Access Compliance Report

Public Rights-of-Way

(Pedestrian Signals)

Intersection ID: N/A	Main Street:	Cross Street: N/A	Location: N/A
ADA ID: 403FC77A5264	Signal Type: One Push Button-Non APS	Overall Compliance: No	Severity Score: BTN 1: N/A BTN 2: N/A No BTN: N/A
Codes/Mitigation Info/Possible Solution		Field Measurements/Component Compliance

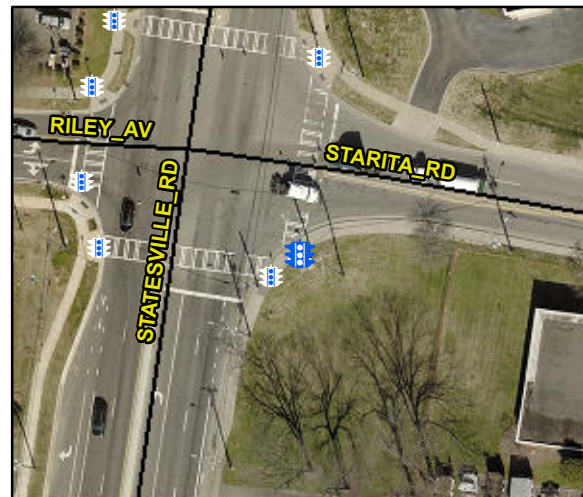
PROW/ADA: TMUTCD 4e.08, R404.2, R404.3

N/A	B 1 Clear Xing Direction?	Yes	N/A	B 2 Clear Xing Direction?	N/A
	B 1 Crossing Direction	To N		B 2 Crossing Direction	N/A
Yes	B 1 DistanceTo XWalk (in)	6.0	N/A	B 2 DistanceTo XWalk (in)	N/A
No	B 1 DistanceTo Curb (in)	83.0	N/A	B 2 DistanceTo Curb (in)	N/A
Yes	B 1 Diameter (in)	2.0	N/A	B 2 Diameter (in)	N/A

Possible Solutions: Replace Signal Push Button With APS Button on New Post. Remove & Relocate Sign.
